**ADDENDUM TO REPORT**  
**INDEPENDENT ASSESSMENT ON EARTHQUAKE PERFORMANCE**  
**OF**

**43 LICHFIELD STREET**  
**(Ballentynes – Anderson Building)**

**FOR**  
**Royal Commission of Inquiry into building failure caused by the Canterbury**  
**Earthquakes**

**February 2012**

Example of typical additional fixing (not detailed in drawings) to panels that remained after 22<sup>nd</sup> February 2011 earthquake.

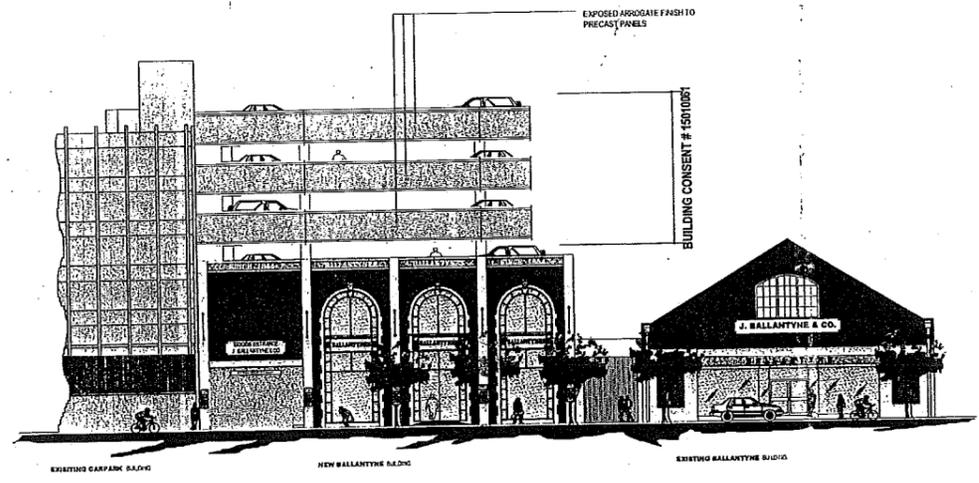
In reviewing the documentation for this project we were aware that there may have been additional fixings provided from the floor to the panel. A typical photograph of such a fixing which applied to a panel that did not fail in the 22<sup>nd</sup> February, 2011 earthquake is appended. It is evident that this fixing failed as a result of the loads imposed on 22<sup>nd</sup> February, 2011 earthquake. The failure appears to have been a failure of the proprietary fixing into the panel. It is evident that the metal cleat suffered severe distortion as a result of forces induced by the earthquake. We are uncertain as to the purpose of the slotted hole or of the location of the bolt located within the slotted hole securing the bracket to the floor at the time of construction.

We are uncertain as to whether a series of these brackets were placed at the junction of the precast panels and the floor during construction as a variation to the contract. As we have not had an opportunity of inspecting the building or the panels prior to removal, we are unable to

comment on whether sufficient of these connections were provided to achieve a restraint of the pre-cast panels under the code loading applying at the time of construction.

Typical Floor Sections			
DESIGNED	D.CUSIEL	JOB No.	<b>4654</b>
DRAWN	R.L.CRAW	SHEET No.	<b>SG6</b>
CHECKED		OF	<b>41</b>
DATE	June 2000		
REV	DATE	BY	AMENDMENT

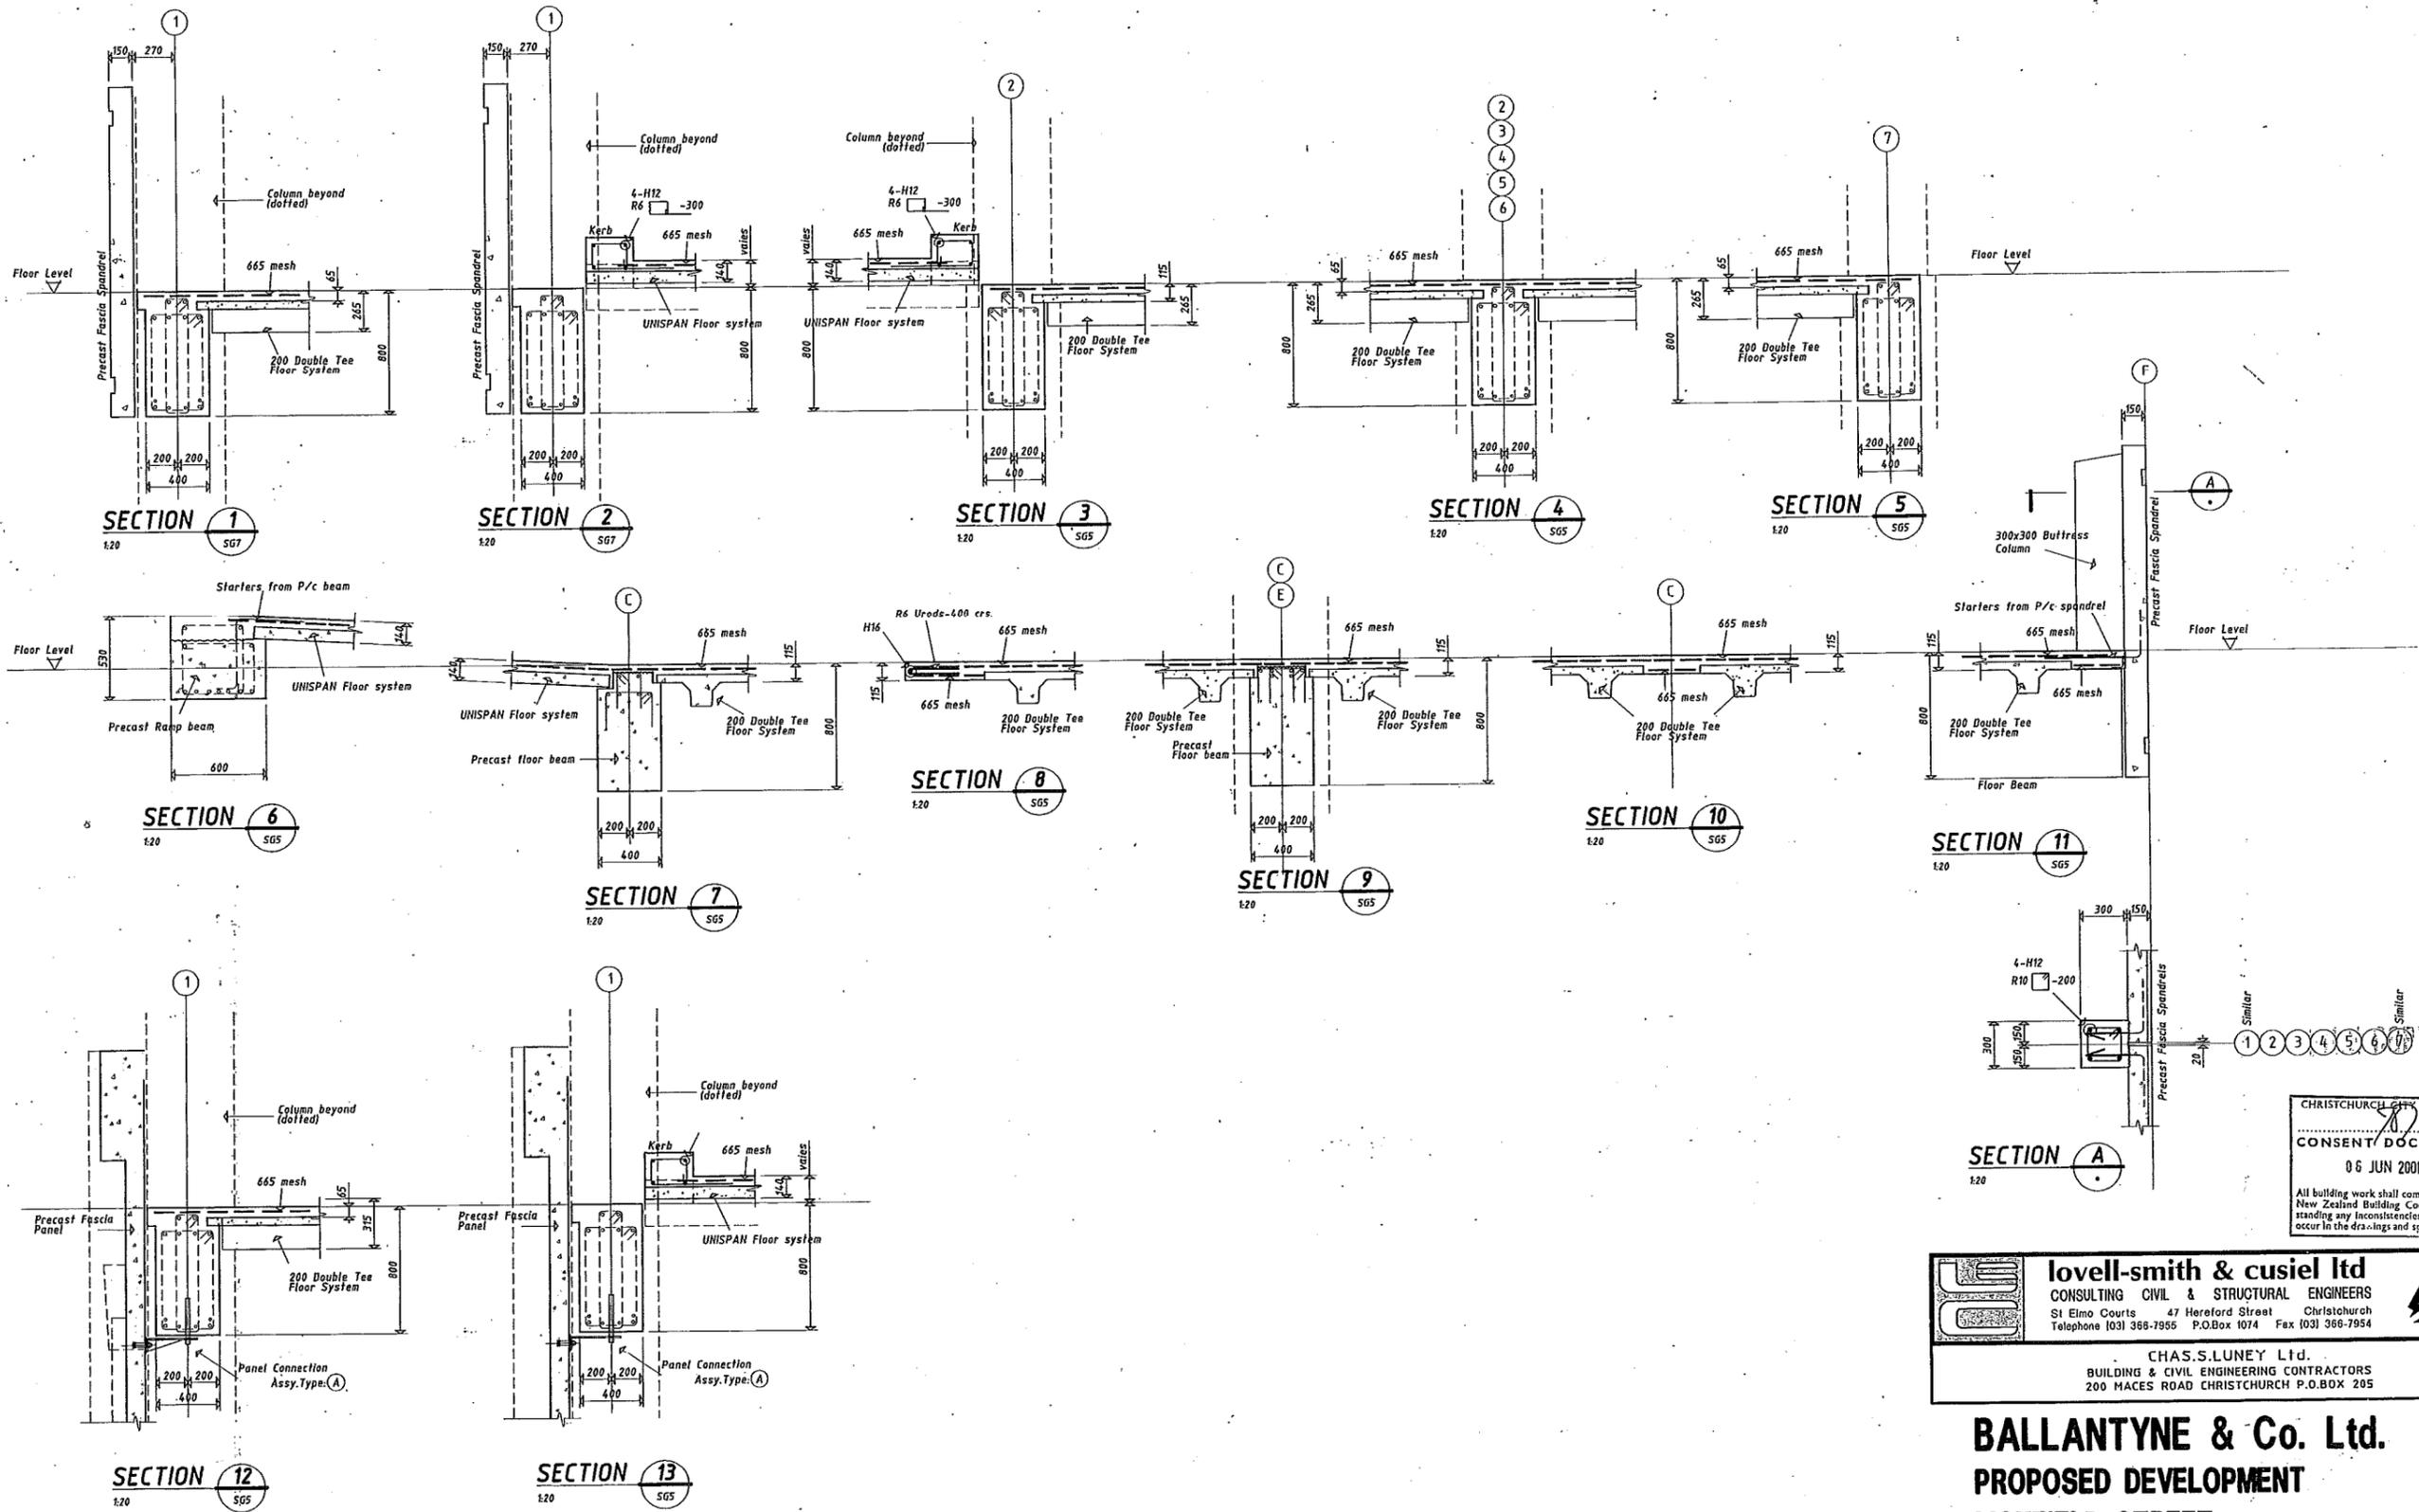
Temporary support for panels S1, S2, S3 was achieved using a seating bracket. In addition to the H12–300 starters cast into the topping of the floor, these panels were restrained by a short column constructed above the main transverse floor beams on Grids 1 to 7 respectively. These columns were 300x300mm reinforced concrete columns reinforced with 4xH12 rods and R10 stirrups at 200 centres. Details of the construction was shown in Section 11 on drawing 4654 SG6

Precast Spandrel Panels			
DESIGNED D.CUSIEL	JOB No. <b>4654</b>		
DRAWN R.L.CRAW	SHEET No.		
CHECKED	DATE		
07.12.00 07.07.00	June 2000	OF	<b>SP7</b> 41
REV	DATE	BY	AMENDMENT

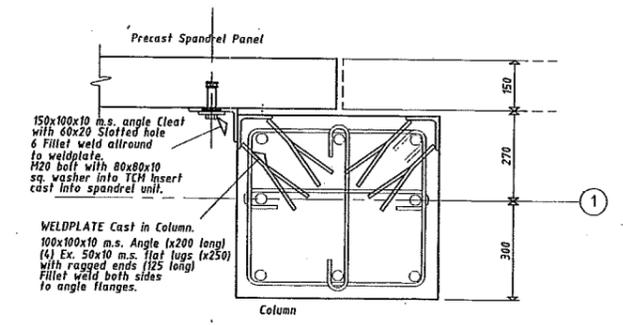
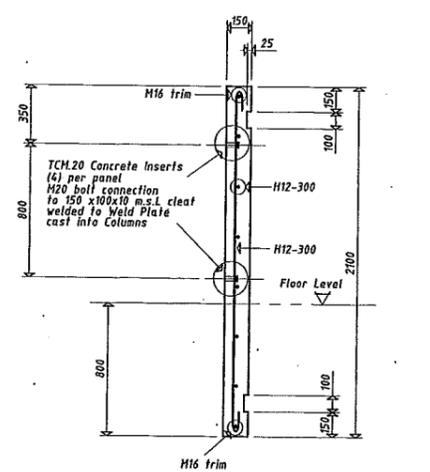
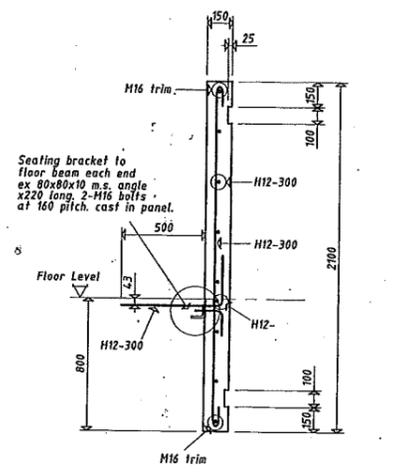
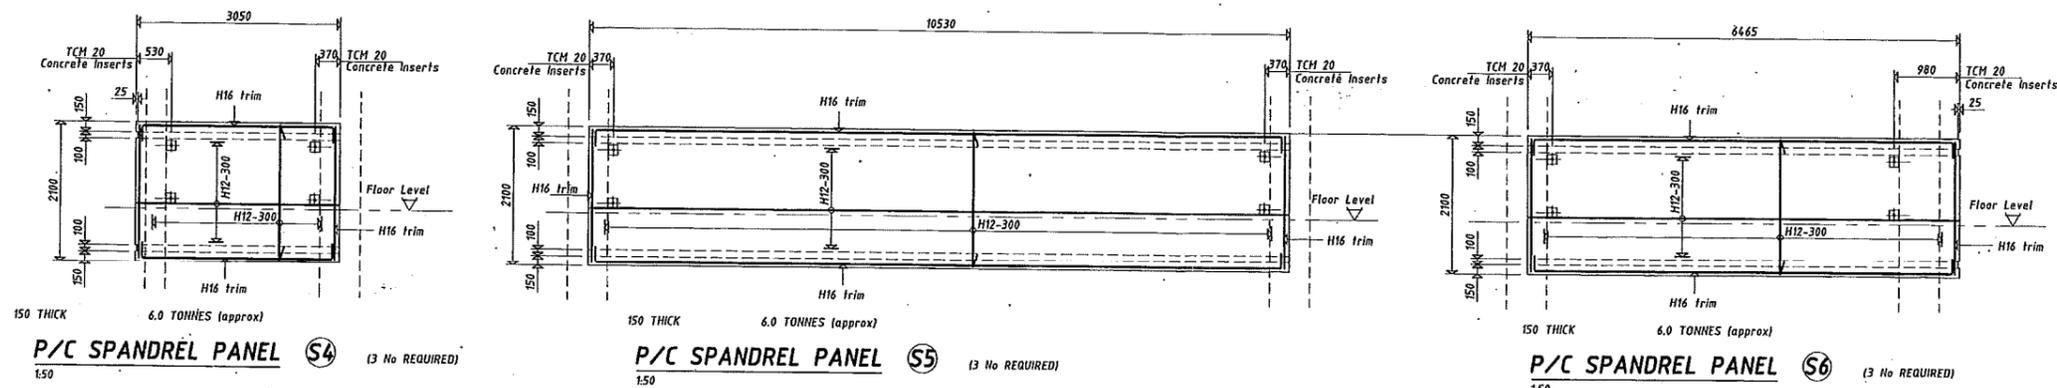
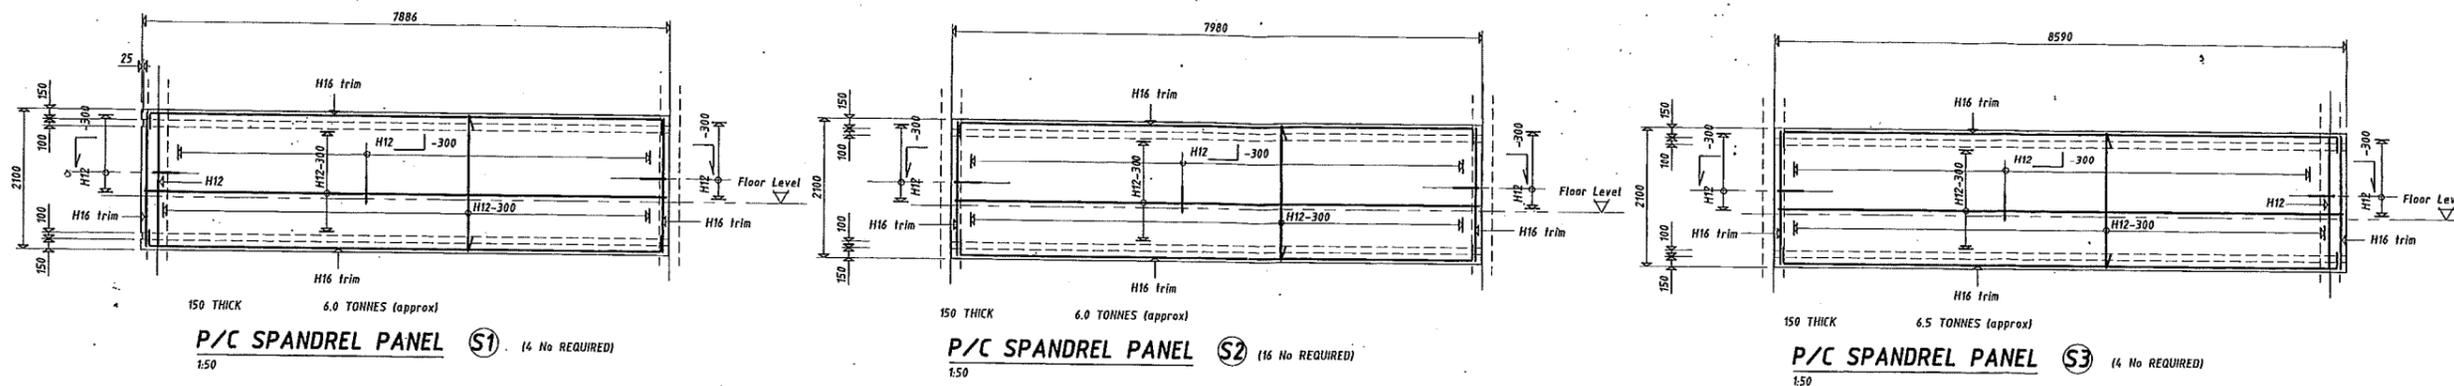
The panels that failed during the 22<sup>nd</sup> February, 2011 earthquake were along the southern (Lichfield Street) frontage of the building at levels 5, 6 and 7 of the carpark. They are identified as spandrel panels S5 and S6 on drawing 4654-SP7. Essential features of these panels are as follows:

The typical fixing details for the panels along Gridline 1 (the Lichfield Street frontage) are shown on drawing 4654-SP7 as "*Typical Connection Details Spandrel Panels Grid 1*".

The panel fixing is detailed with "*100x100x10 m.s. Angle cleat (x200 long) (4) Ex. 50x10 m.s. flat lugs (x250) with ragged ends (125 long) Fillet weld both sides to angle flanges.*". This 100x100x10 angle and attached metalwork was cast into the corner of the concrete columns.

The panels were detailed with a TCM insert cast into the panel for an M20 bolt. The panel was fixed to the angle embedded in the concrete column with a "*150x100x10 m.s. Angle Cleat with 60x20 Slotted hole*". The connection between the 150x100x10 mild steel angle and the 100x100x10 mild steel angle was detailed as a 6mm fillet weld all round to weldplate.

It is assumed that the length of the 150x100x10 mild steel angle was less than the 200mm length of 100x100x10 mild steel angle.

The fixing of the spandrel panels on Gridline 1 (South Wall) differed significantly from the spandrel panel fixing adopted for the support of the spandrel panels to Gridline F (East Wall). The connection of the panels to the east wall was achieved with H12-300 starters embedded in the pre-cast panel and subsequently cast into the 65mm topping to the floor. Refer typical sections for Pre-cast Spandrel Panels S1, S2, S3 on drawing 4654-SP7.

We have undertaken an assessment of the capacity of panels S5 and S6 and of the fixings of these panels in accordance with NZS 4203:1992, the current code applicable at the time of design. In order to carry out our assessment we have assumed the primary building structure to have a period of 1.0 seconds, and from this have calculated the applicable design seismic coefficient for the panels to be 1.35g.

PANEL	PERCENTAGE OF DESIGN CODE (NZS 4203:1992)	
	Panel Strength	Fixing Capacity
S5	27%	15%
S6	99%	33%

Clearly the panel fixings as detailed on the drawings did not comply with the current code NZS 4203:1992.
